Public Works and
Government Services
Canada

AMENDMENT/AMENDEMENT 004

Solicitation No. - N° de la demande W3915-23-0039	Amendment No. - N° de modification
Supplier SA No. - N° de l'AMA de fournisseur : E60PQ-140003/___

Amendment 004 to Solicitation W3915-23-0039 is raised to answer questions and amend the close date due to the number of questions:

See above for general floor plan

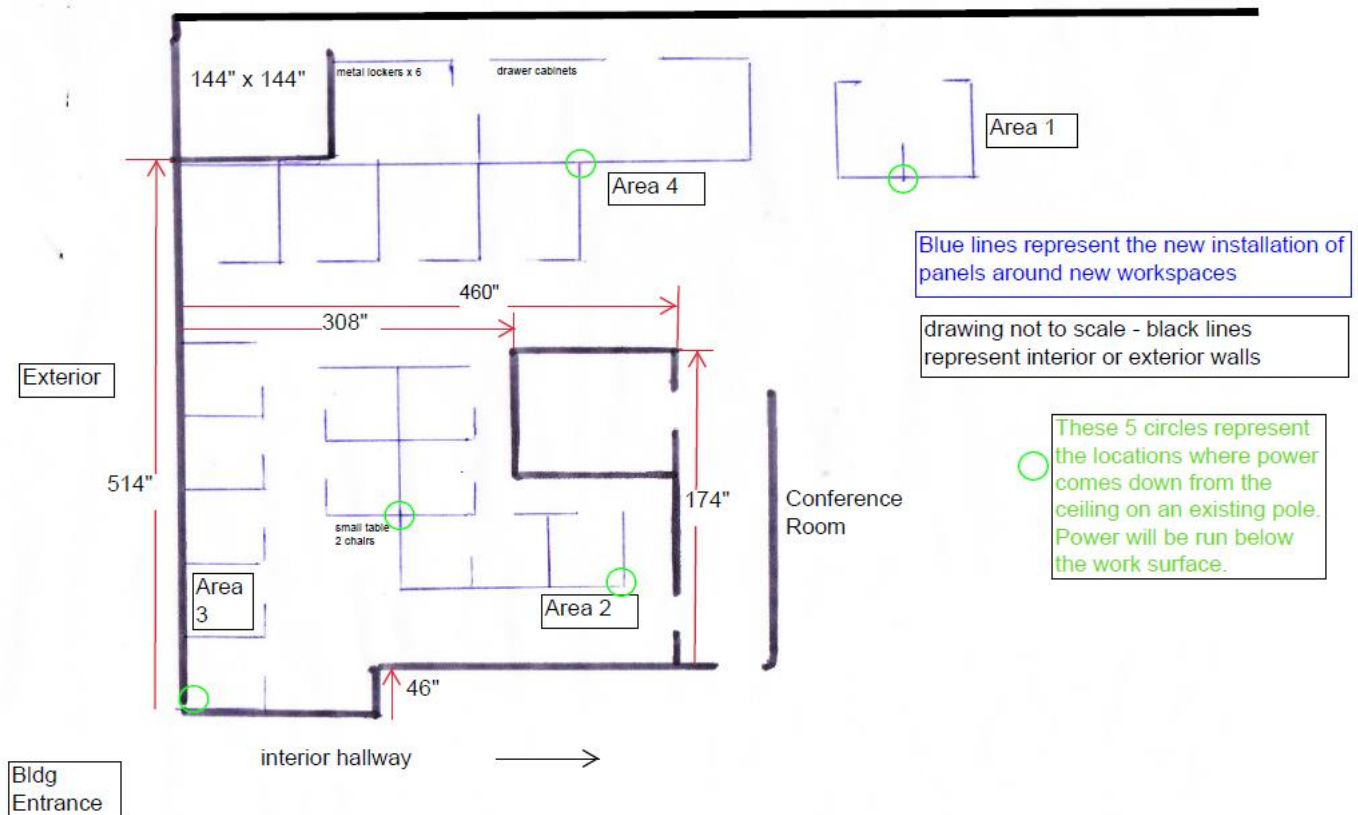
Question 7:

Regarding Question/Answer #6 on Addendum #3 – panel heights.

Please highlight on the plan(s) provided in Annex C the 7 panels that are to be the work surface privacy (34" base panel + 8" Stack)

Answer 7:

Highlighted in green below.

Row of four

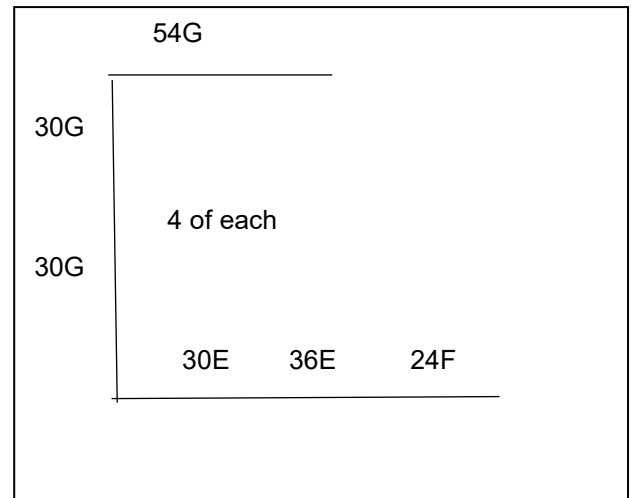
Question 1:

Question 2:

What location CAT 1B Item #10 - 4 QTY of 30" x 30" fixed height work surface go?

Question 3:

What type of supports are required CAT 1B Item #10 - 4 QTY of 30" x 30" fixed height worksurface - eg are these to be panel attached?

Apologies amendment 2 did not answer the question. I have reattached Annex C and highlighted in yellow the wording that indicated the presence of 90" x 90" workspaces. Below is an excerpt from the general drawing to show the 90"x90" workspaces that are part of "area 4".

These go into the 90" x 90" workspace. As you walk in to the space, in front of you is a tall cabinet to the right of that the 2335 work surface meeting up perpendicular to the 2958 HA table with the 3030 work surface beside it. Under the 3030 work surface is a pedestal. Also see question and answer number 5.

Answer 3:

These can be panel attached. We have no preference they can be affixed to the panel or have support legs.

Section of five workspaces plus 2 separate storage areas

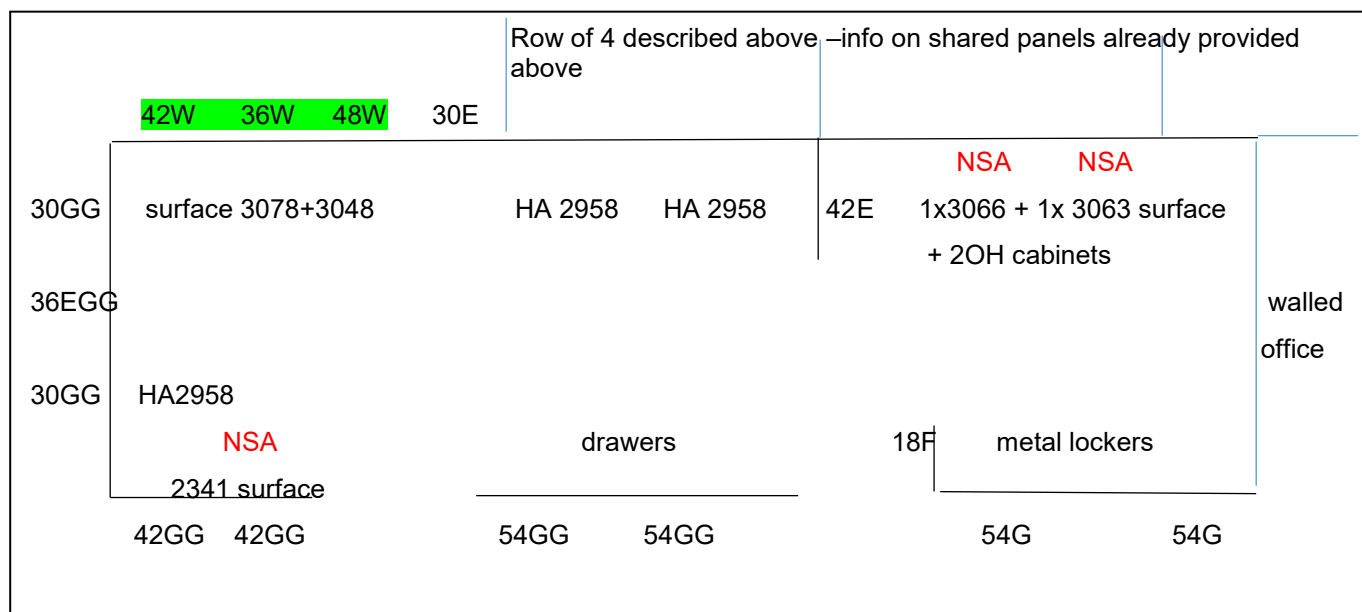
Question 5:

Regarding question #3 on Addendum #3. The answer states to refer to Addendum #2, however Add #2 does not address a 30x30 CAT1B work surfaces. Addendum #2 is about two NSA category work surfaces. Additionally, we cannot locate a 90x90 workspace. Can you please provide further clarity on where these two work surfaces go on the plan?

Are you able to provide a sketch?

Question and Answer 2 above refer to the 90" x 90" workspaces. I assume that the 2 work surfaces in your question are just the NSA work surfaces. These are marked on the 2nd to last page below as taken from the original RFP.

I will try to obtain a sketch and upload it before 9 January.
